Re: Chelsea Gardens Estate

SEEC have been invited by Aoyuan International (our client) to respond to peer reviewed comment on SEEC report 2000035-LC by 03/05/2022 to align with a scheduled meeting between the client and Wingecarribee Shire Council. The report in question has multiple revisions it is assumed the comments made relate to the latest revision 20000305-LC-03 dated 6/11/2020. Comments made by the peer reviewer and SEECs response are presented below:

Copy of Figure 2 from Harvest Report 2006.

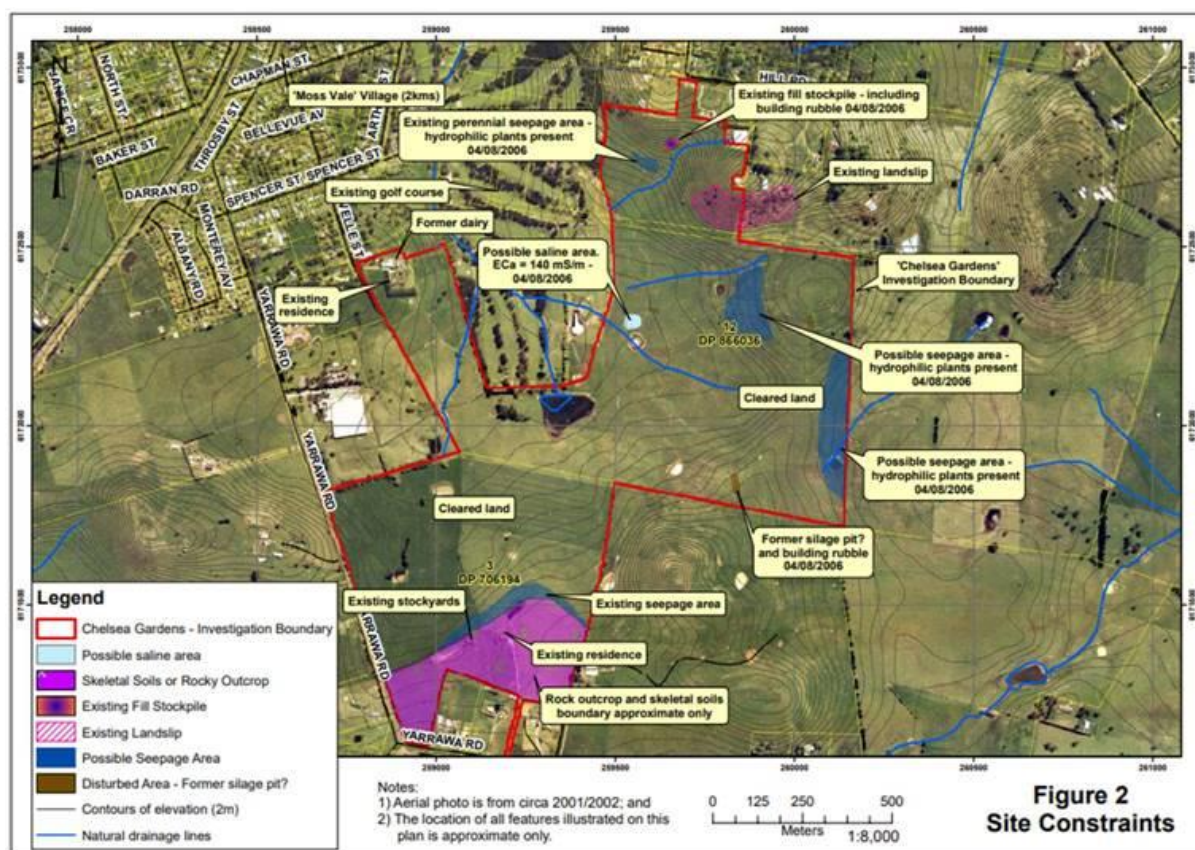
"...the LCA outcomes for site hydrology and groundwater do not align with the previously completed Capability Assessment by Harvest Scientific Services (2006) which identified high groundwater value and the presence of both intermittent and perennial seeps. Two intermittent seeps were identified by Harvest within and immediately downslope of the proposed irrigation areas."

At Page 7, an area of seepage is reported as having been observed around the rock outcrop on the south-east portion of the site (currently planned for Stage 2). This area is identified in Figure 2 as being around the perimeter of the purple-coloured rock area and is distant from the proposed irrigation area in the east of the site.

Further, an existing perennial seepage area is noted as having been observed in the northern portion of the site. This area is located to the north of Shelly Road in Figure 2 and again distant from the proposed irrigation area.

At page 7, the report there is a comment that “rush plant species (*Juncus* sp) were observed sporadically over the major part of this site. This plant species indicates that the site is probably poorly drained (in places) and possibly intermittently saturates.” There are two areas in Figure 2 which are adjacent to the proposed irrigation area where these plants were observed. It is noted that these areas are not identified as seepage areas, just areas with rush plants.

At page 20, the Harvest Report confirms that “During field investigations on the 4th of August, 2006, two main areas of seepage were observed on this property (Figure 2). The first

of these was located in the northern portion of the CGDS in the steep area near hill road and the second occurs in the southern portion of this CGDS at the base of the syenite/microsyenite plateau.” Both of these areas are identified in Figure 2 and are both distant from the proposed irrigation zone.

In conclusion, I have reviewed the 2006 Harvest Scientific Services report and the SEEC land Capability Assessment against the comments in the DWA Peer Review and cannot find any evidence to support the findings of the peer review. The Peer Review states that the Harvest Report found high ground water values but there are no such references in the Harvest Report in the area of the proposed irrigation area. The Peer review infers that the Harvest Report found perennial and intermittent groundwater seeps in the vicinity of the proposed irrigation area but the only seepage areas identified in the Harvest Report are located well to the north and south of the proposed Irrigation area which will not be impacted upon or impact on the proposed irrigation area. The Peer Review states that “Two intermittent seeps were identified by Harvest within and immediately downslope of the proposed irrigation areas.” This is factually incorrect. The two areas immediately downslope of the proposed irrigation area were identified in the Harvest Report as “possible seepage areas” based on the vegetation observed on site only. Subsequent test pit data obtained by SEEC did not identify any saturation issues with the soils in these areas.”

Figure 4: Soil Landscapes and Location of Test Pits.

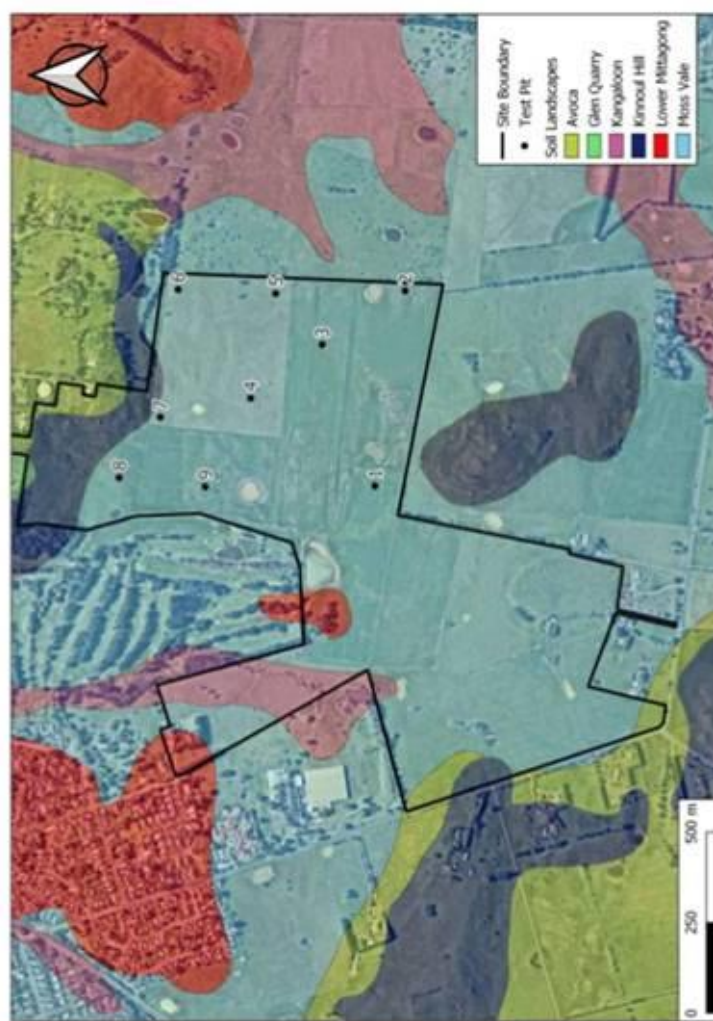
It is noted that SEEC Test pits 2 and 5 are located in the eastern blue area marked in the Harvest Figure 2 as a “possible seepage area” and that SEEC Test pits 4 and 7 are in the

other blue area marked in the Harvest Figure 2 as “possible seepage area” located to the immediate west of the proposed irrigation area.

These SEEC test pits were excavated to a depth of at least 1m and no sign of saturation or seepage was noted. The soils were generally classified as being “moderately well drained”.
